UNITED STATES PATENT AND TRADEMARK OFFICE

APPLICATION NO.	FILING DATE	FIRST NAMED INVENTOR	ATTORNEY DOCKET NO.	CONFIRMATION NO.
10/815,654	04/02/2004	Shunpei Yamazaki	0756-7279	9416
31780 7590 06/29/2010 Robinson Intellectual Property Law Office, P.C. 3975 Fair Ridge Drive Suite 20 North Fairfax, VA 22033				
EXAMINER				
KARIMY, MOHAMMAD TIMOR				
ART UNIT		PAPER NUMBER		
2894				
MAIL DATE		DELIVERY MODE		
06/29/2010		PAPER

Office Action Summary

DETAILED ACTION

FIG. 1

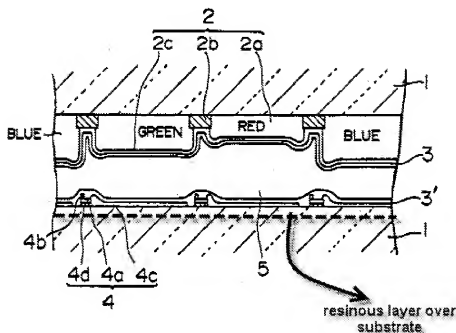
Regarding claim 48, Shimizu teaches in figures 1-3 a semiconductor device comprising:

- a pair of flexible insulating substrates 1 opposing to each other (Fig. 1);

- a resinous layer (upper surface portion of substrate 1) formed over one of the pair of the flexible substrates 1 (see Fig. 1 below);

- a thin film transistor 4 formed over the resinous layer, the thin film transistor having a semiconductor film comprising silicon (inherent, column 2 and line19); and

- a layer 3 comprising resin covering the thin film transistor 4 (Fig. 1), wherein the semiconductor device is flexible (due to usage of resinous substrate, the device is flexible).

a pair of flexible insulating substrates 1 opposing to each other (Fig. 1);
a resinous layer (upper surface portion of substrate 1) formed over one of the pair of the flexible insulating substrates 1 (see Fig. 1 above);

a layer 3 comprising resin covering the thin film transistor 4 (Fig. 1), wherein the semiconductor device is flexible (due to usage of resinous substrate, the device is flexible).

7. Applicant's arguments with respect to claims 48, 52, 66, 61-63 and 66-71 have been considered but they are not found to be persuasive. Examiner submits that upper portion of the flexible substrate, as shown in Shimizu's Fig. 1 above, is interpreted as "a resinous layer". The line drawn and the label added by examiner has been included only to communicate properly examiner's application of prior art on the claims. Moreover, examiner maintains that the claims limitations remain broad and the prior arts, as applied above, meet the structural limitations of the claims. Lower portions of reference numeral 1 meets the feature "flexible insulating substrate" and upper portion of the reference numeral 1, as shown in Fig. 1 above, meets the feature "resinous layer". Shimizu expressly teaches in column 3, lines 40-42, wherein reference numeral 1 of Fig. 1 comprises resinous insulating material.
